County of Loudoun
Department of Planning
MEMORANDUM

SUBJECT: **SPEX 2006-0044 & CMPT 2006-0009**
Loudoun County Schools – Grubb Property 2nd Referral

ZONING ADMINISTRATION REFERRAL

DATE: February 27, 2007
TO: Miguel Salinas, Project Manager, Planning
THROUGH: Mark Stultz, Deputy Zoning Administrator. *MS*
FROM: Claire Gron, Planner, Zoning Administration *CG*
SUBJECT: SPEX-2006-0044/CMPT-2006-0009
LCPS Grubb Property (1st Referral)

**GRAPHIC 2: EXISTING SCHOOL SITES -
WESTERN LOUDOUN**

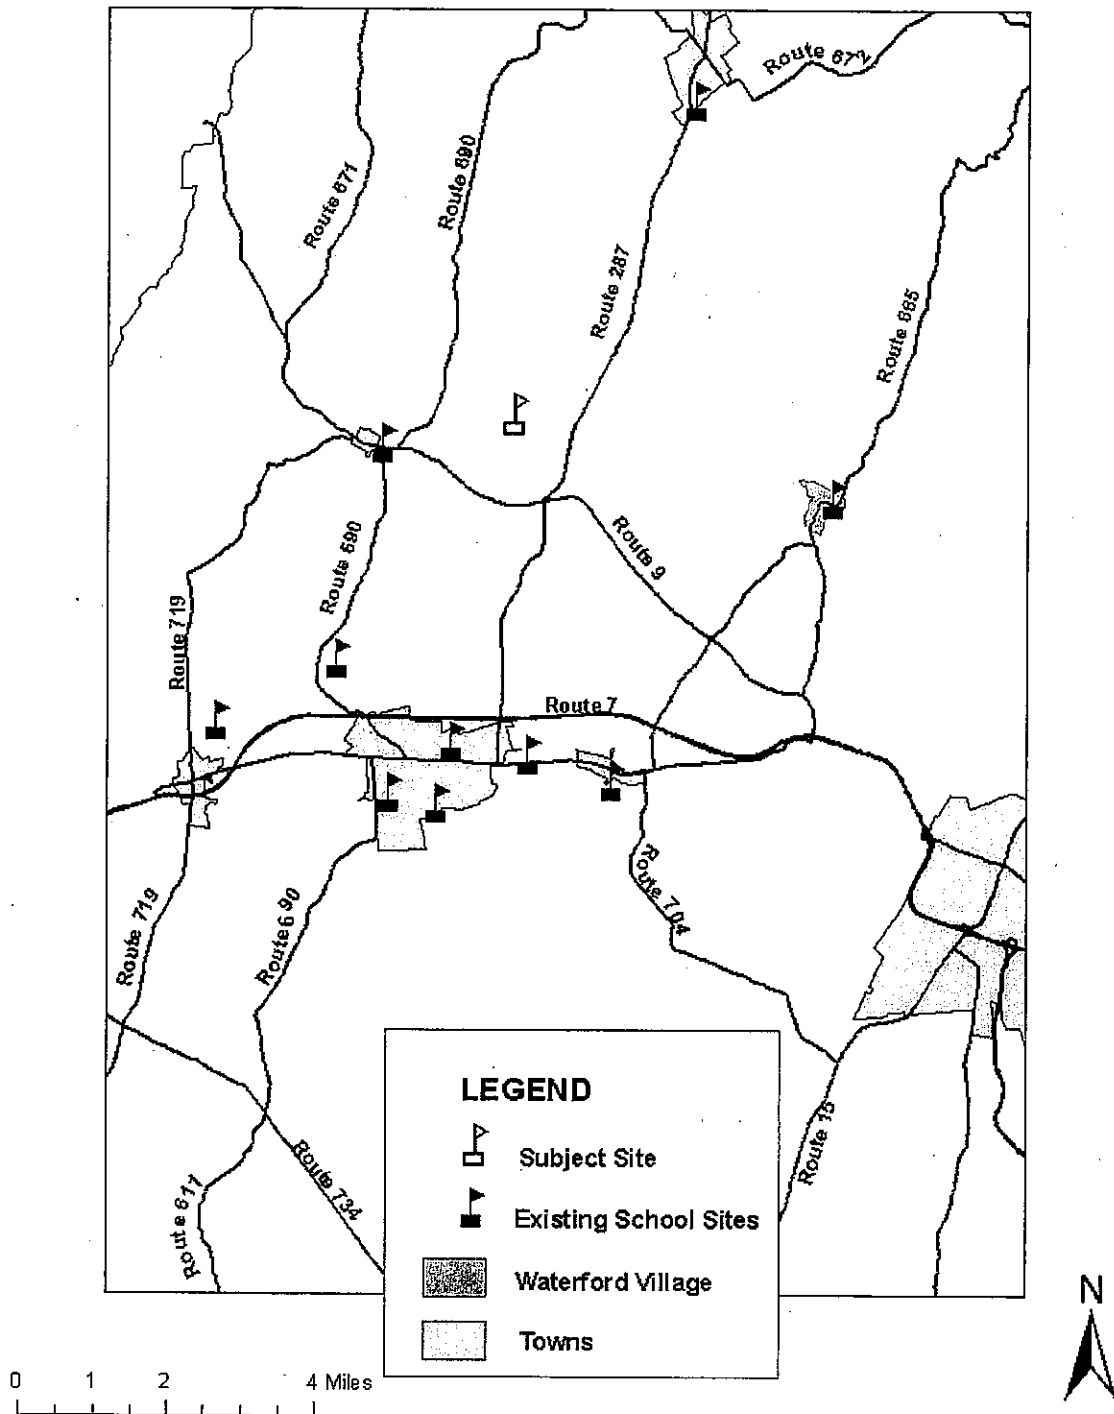
The historical development pattern for school sites has, for the most part, followed plan policies related to the County's growth management strategy - in particular plan policies that call for new school sites located within or adjacent to Towns, Villages or Joint Land Management Areas. Graphic 1, provided by Loudoun County Public Schools, demonstrates the subject property as being 3.5 miles from the Town of Hillsboro and 5.3 miles from the Town of Lovettsville. The proposed location of the schools does not conform with the policies of the Revised General Plan. Graphic 2 on the other hand, which shows the location of existing schools within LCPS's Loudoun Valley Cluster and their relationship to the County's Towns and Villages, demonstrates Loudoun County's historical adherence to county plan policies for the location of new school facilities³.

³ The Graphic excludes Banneker Elementary School located south of the map boundary. Lincoln Elementary School, located south of Route 7, also is not depicted on the map but is located adjacent to Purcellville's JLMA.

GRAPHIC 2: EXISTING SCHOOL SITES - WESTERN LOUDOUN

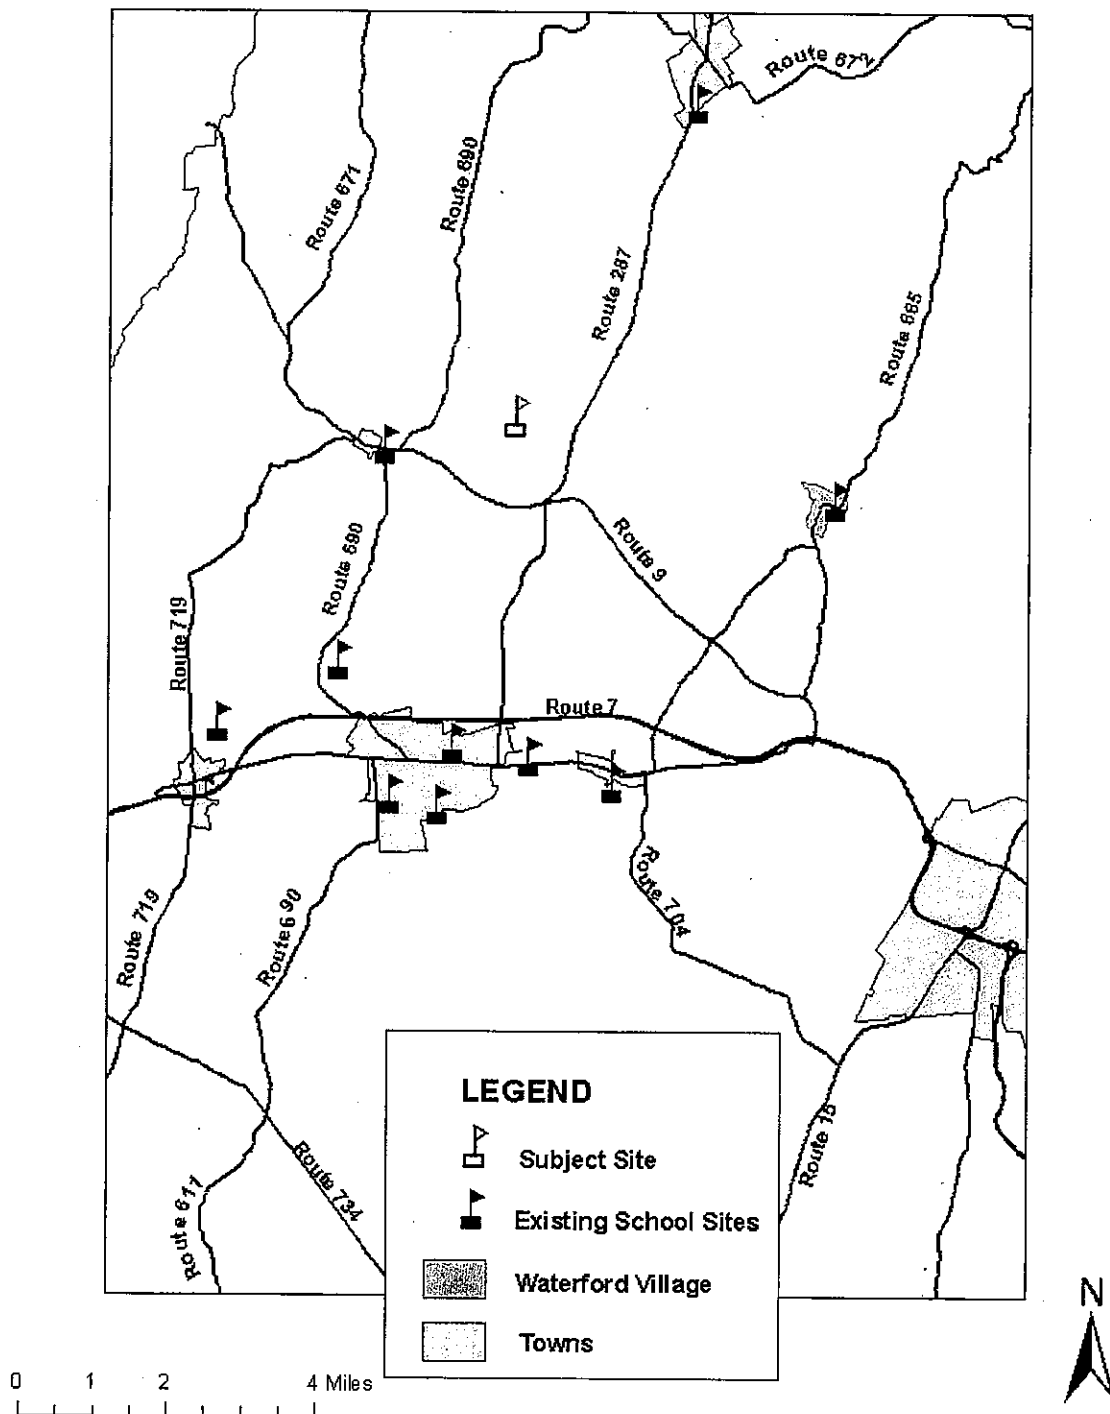
Graphic 2 below indicates historical adherence to this policy. The graphic shows the location of existing schools within the Loudoun County Public School's Loudoun Valley Cluster and their relationship to existing towns and villages¹. The graphic also shows the location of the subject site. The pattern of development for school sites has been to locate within Towns, Villages or Joint Land Management Areas – i.e., near population centers in western Loudoun where existing infrastructure can be utilized, where the intensity of the use is more compatible with the surrounding areas, and where greater accessibility can be achieved.

¹ The Graphic excludes Banneker Elementary School located south of the map boundary. Lincoln Elementary School, located south of Route 7, also is not depicted on the map but is located adjacent to Purcellville's Joint Land Management Area.

**GRAPHIC 4: SUBJECT SITE SHOWING BOUNDARIES OF
STREAM CORRIDOR RESOURCES**

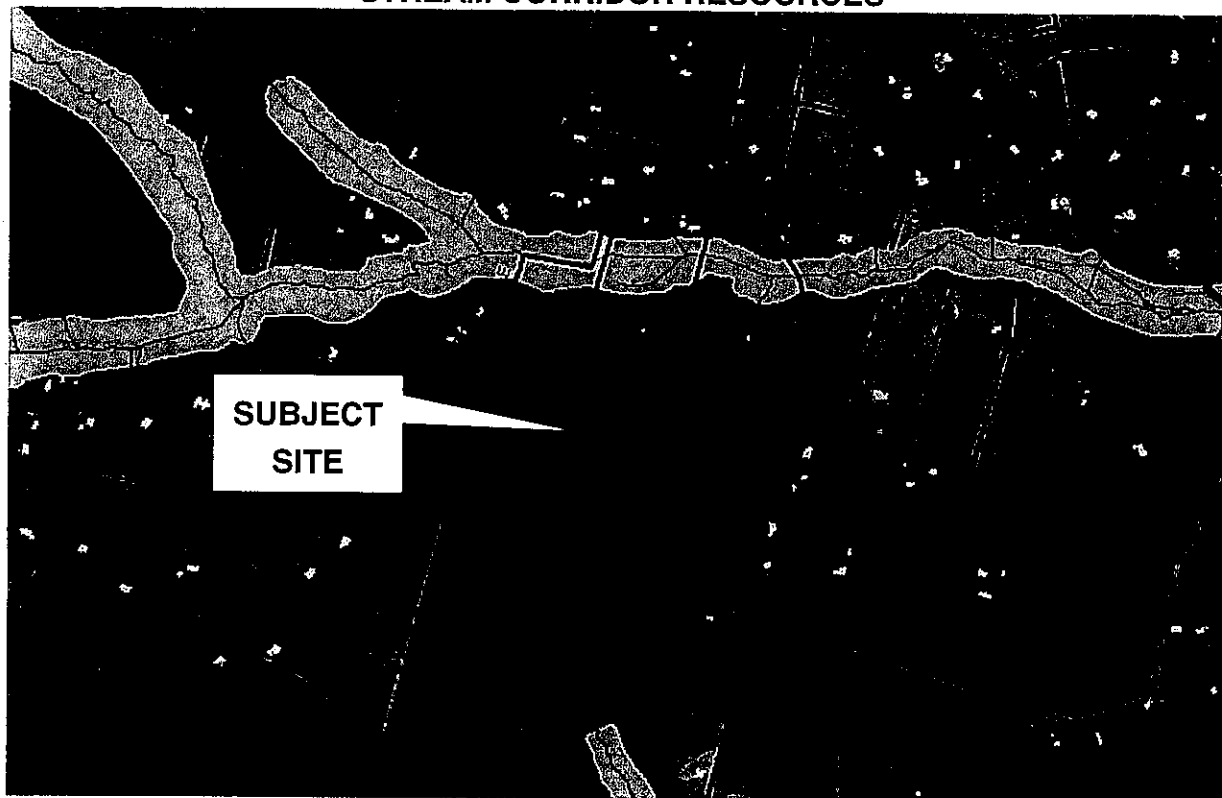
Within the floodplain and 50-foot management buffer, uses are limited to activities that will support and enhance the biological integrity and health of the river and stream corridor, including passive and active recreation, road crossings, pervious paths and trails, and agricultural activities (Revised General Plan, Policy 18, p. 5-10). The applicant's Special Exception Plat (Sheet 2 of 4) shows no disturbance to stream corridor resources. However, a conceptual stormwater management (SWM) facility is located at the northwest corner of the subject site and appears to be within the 50-foot management buffer. Local stormwater management facilities can be located within the 50-foot management buffer, provided best management practices are applied (Revised General Plan, Policy 18c, p. 5-10).
